VERMONT YANKEE NUCLEAR POWER CORPORATION

November 17, 1999
BVY 99-140

**Subject: Vermont Yankee Nuclear Power Station
License No. DPR-28 (Docket No. 50-271)
Supplement to Technical Specification Proposed Change No. 207
Spent Fuel Pool Capacity Expansion**

Technical Report for the Vermont Yankee Spent Fuel Pool Storage Expansion
and Proprietary Information Affidavit

FIGURE 2.1: POOL LAYOUT FOR VERMONT YANKEE

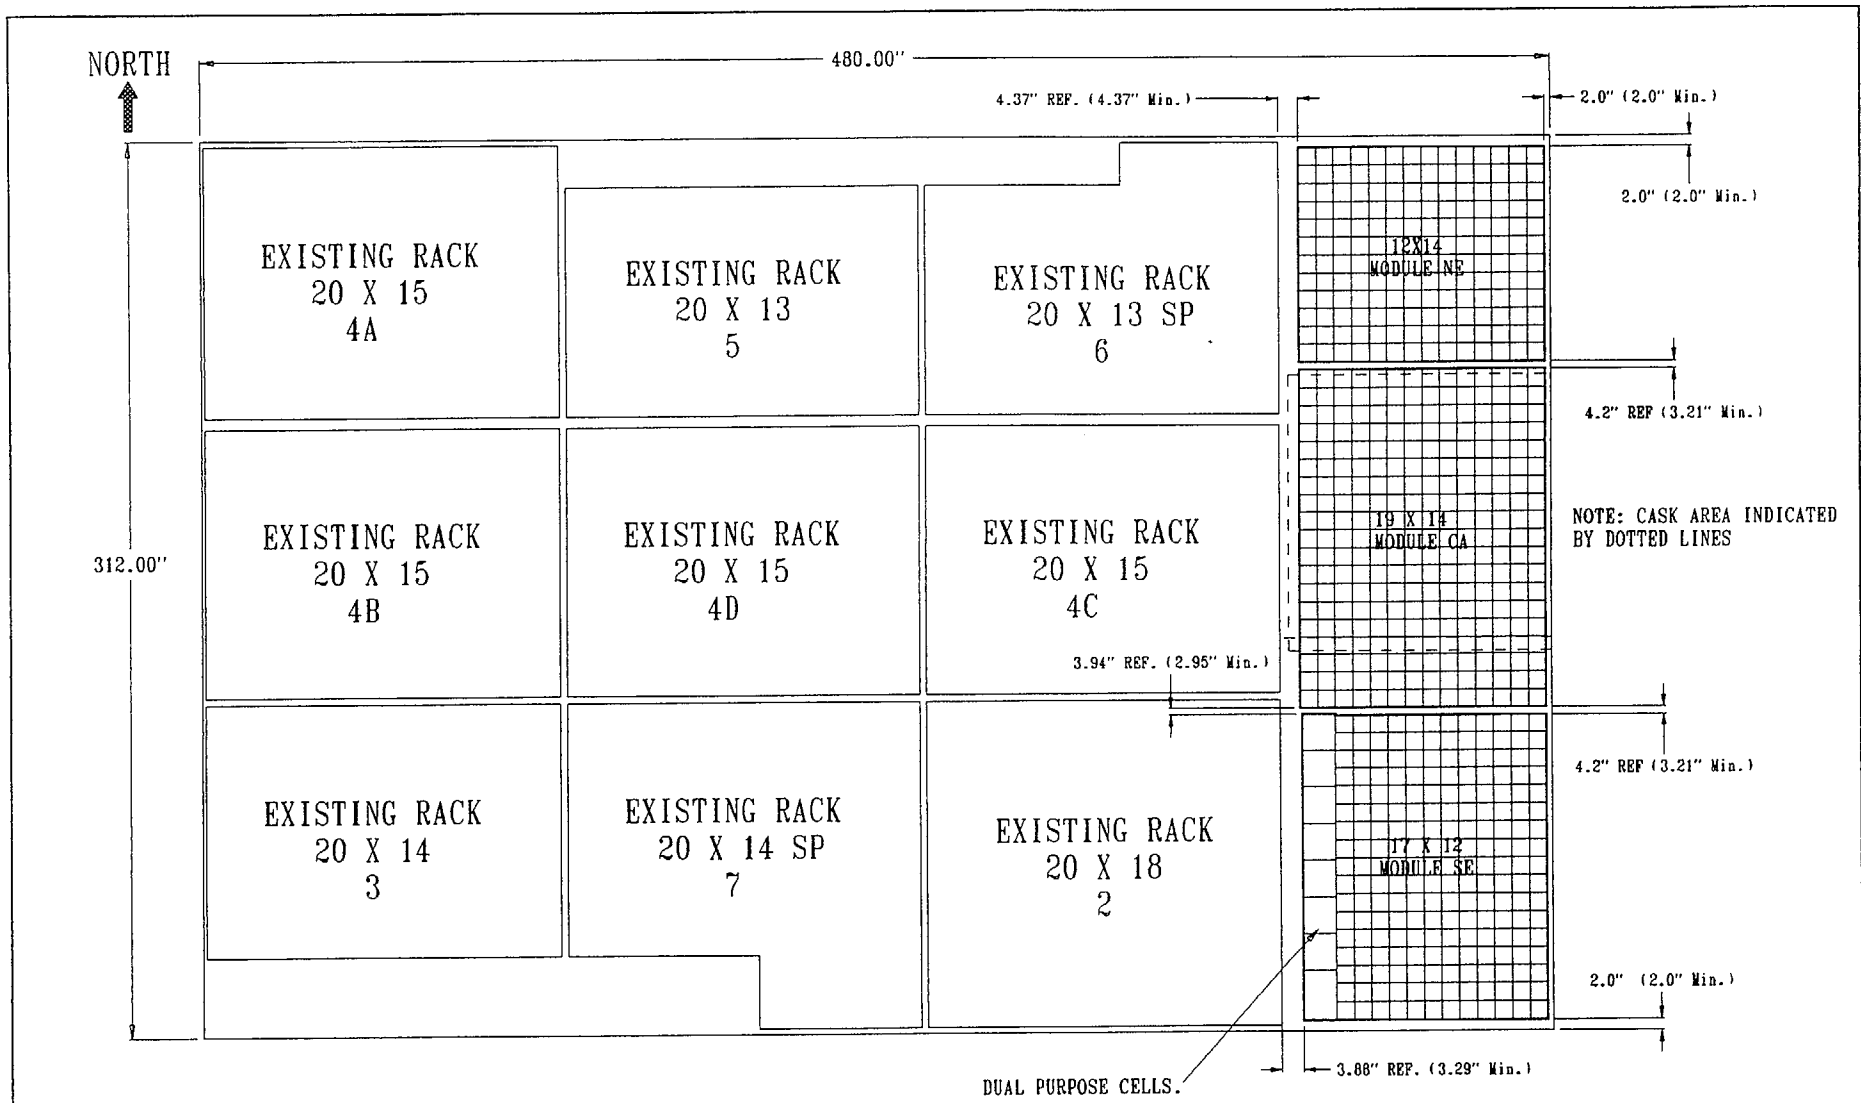
During development of the final design details, two peripheral cells from the corner of rack SE were eliminated. The attached revised pages of the Holtec International Technical Report provide additional information about this change. This reduces the maximum number of fuel assemblies proposed to be stored in the spent fuel pool from 3,355 to 3,353.

It should be noted that in this revision i.e. revision 4.0 of this amendment report, the two peripheral cells located in the north-west corner of rack SE have been removed so that this module now has a

rectangular planform which would result in reduced welding induced distortion in the manufacturing of the rack. Additionally, the removal of these cells enables the cell opening of 8 dual purpose cells of this rack to be increased by a small amount to facilitate ease in installation of fuel assemblies and control rod blades. As a result of these changes, the envelope dimensions of rack SE are very slightly changed (from 108.20 x 87.916 inches to 106.042 x 88.512 inches). The weight of rack SE reported in this report remains bounding and therefore, has not been changed. All analysis disciplines including rack seismic, pool structural, mechanical accidents, thermal hydraulic, criticality and radiological performed in support of this amendment report have been carefully evaluated to assess the consequences due to this change. This evaluation has concluded that the safety margins reported in this report remain bounding and conservative.
